COMMENTS AND RESPONSE REPORT

Bitou Municipality Land Use and Environmental Management via Email on Pre-App DBAR	
COMMENTS	RESPONSE
<p>It is requested that the proposed Nature Conservation Areas be formally declared as Protected Environment in terms Section 28 of the National Environmental Management: Protected Areas Act (NEM:PAA, Act 57 of 2003) to be able to give legal recognition of the sensitivity of the site. As such, Open Space Zone IV in the Bitou Zoning Scheme (2023) would be the appropriate zoning to apply for.</p>	<p>The environmental application stipulates that the remaining natural area is a No-Go area (irrespective of the final zoning) and it must be managed as a conservation area in any event.</p> <p>Apart from the already existing walkways/paths, pedestrian routes and dedicated vehicle routes for fire management and invasive alien management, the open space area must be managed by the applicant and in the future, the Managing Agent or Body Corporate / Homeowners Association of the proposed Plett Lagoon Estate.</p> <p>The long-term responsibilities of the applicant / HOA will be as follows (irrespective of the open space area being zoned Open Space III or IV):</p> <ul

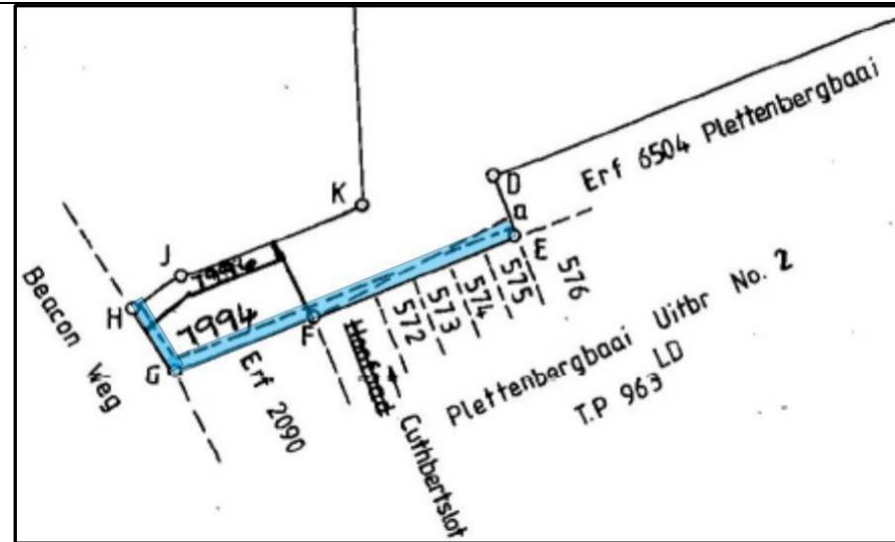
<p>The Bitou Municipal Waste Water Treatment Plant must have the capacity to handle the additional load without any negative effect.</p>	<p>The Ganse Vallei Wastewater Treatment Works (WWTW) has an effluent discharge capacity of 6MI per day and is currently at an average daily discharge volume of 5.8MI.</p> <p>According to Bitou Municipality the remaining 0.2MI is reserved for approved developments.</p> <p>Upgrades to the Ganse Vallei WWTW is therefore required to accommodate new developments.</p> <p>Due to the fact that said upgrade of the WWTW may take some months/years still (considering approvals / funding / delays etc), the proposal for this development is for the installation of an on-site package plant.</p>

The temporary on-site package plant (fully enclosed) is proposed to be installed inside a 12m container directly adjacent to the proposed maintenance building at the entrance of the proposed development.

The temporary package plant will have a treatment capacity of 40m³ per day and will use a combination of conventional treatment (natural bacteria) and membrane technology (microfiltration) to treat the household sewage to comply with general water limits stipulated by the Department of Water Affairs.

For the duration of the package plant being in operation, all treated effluent is then to be used for irrigation within the estate. Dedicated irrigation storage tanks (4 x 10KI) forms part of the design and will be located next to the container.

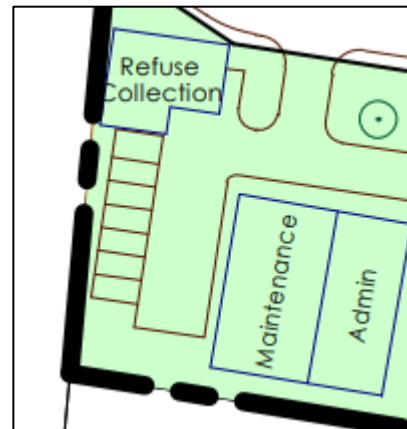
The portion of the proposed development directly abutting the Checkers shopping centre delivery yard, i.e. the gatehouse and entrance lanes, is positioned in very close proximity to our boundary wall. Although there is a small buffer proposed between the entrance lanes and our boundary wall, we are concerned about the potential impacts of this portion of the development on the structural integrity of said boundary wall. We thus request more detail, including height levels and a section / elevation of this portion of the development to depict how same will interface with our boundary wall.

Following input from authorities and the public during the public participation process, the site development plan has been amended.

Detailed building design has not commenced as yet, however, the proposed entrance have been moved from the corner of Cuthbert Close/Susan Street to between the Checkers Centrum and the Plettenberg Bay Primary School.

The site is to be fenced and a small parking area is proposed abutting the Checkers boundary wall.
